Administrative Order SWD-1744 August 28, 2018

ADMINISTRATIVE ORDER OF THE OIL CONSERVATION DIVISION

Pursuant to the provisions of Division Rule 19.15.26.8(B) NMAC, Delaware Energy LLC (the "operator") seeks an administrative order for its Ruehle SWD Well No. 1 (the "proposed well") with a location of 660 feet from the South line and 660 feet from the East line, Unit letter P of Section 28, Township 23 South, Range 27 East, NMPM, Eddy County, New Mexico, for the purpose of commercial disposal of produced water.

PROPOSED WELLBORE

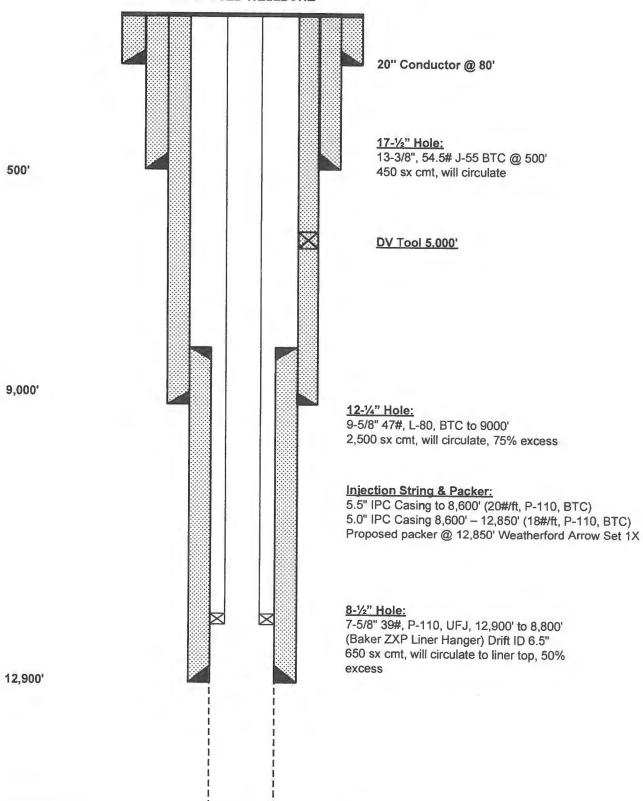
The operator shall run a CBL (or equivalent) across the 7%-inch liner from 500 feet above the liner to the bottom of the liner to demonstrate placement cement across the length of the liner and the cement bond with the tie-in with the 9%-inch casing. The operator shall provide a copy of the CBL to the Division's District II prior to commencing disposal.

The 20-inch conductor casing to be set from surface to an approximate depth of 80 feet shall be cemented as to prevent migration of fluids and seal the interval between the surface and the bottom of the casing.

After installing tubing, the casing-tubing annulus shall be loaded with an inert fluid and equipped with a pressure gauge or an approved leak detection device in order to determine leakage in the casing, tubing, or packer. The casing shall be pressure tested from the surface to the packer setting depth to assure casing integrity.

The wellhead injection pressure on the well shall be limited to **no more than 2580 psi.** In addition, the disposal well or system shall be equipped with a pressure limiting device in workable condition which shall, at all times, limit surface tubing pressure to the maximum allowable pressure for this well.
